NEWSLETTER DECEMBER 2009

Improved DTZK-25 and -37

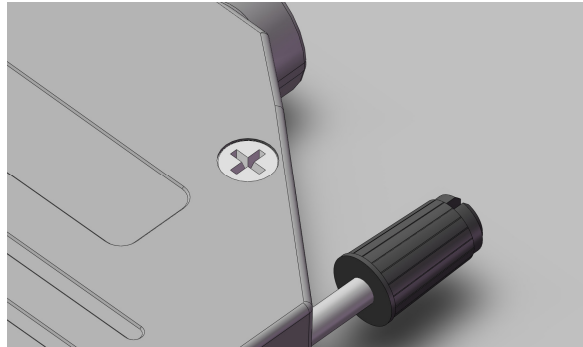
During the last couple of month's we have made some changes to our size 25 and 37 diecasted zinc hoods with straight cable entry. The new versions are lighter and designed to improve the die-casting process regarding burs and ejector marks

New mounting screws for DTZK37

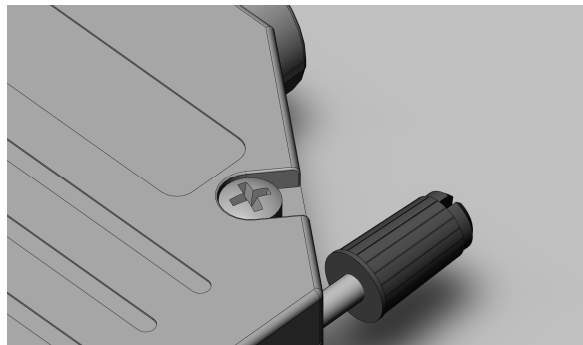
We have changed the mounting screws for our DTZK37, so that our complete range now uses the same countersunk type.

The changes will be effective from today

New countersunk flat head (DTZK37)

Old Pan head type (DTZK37)
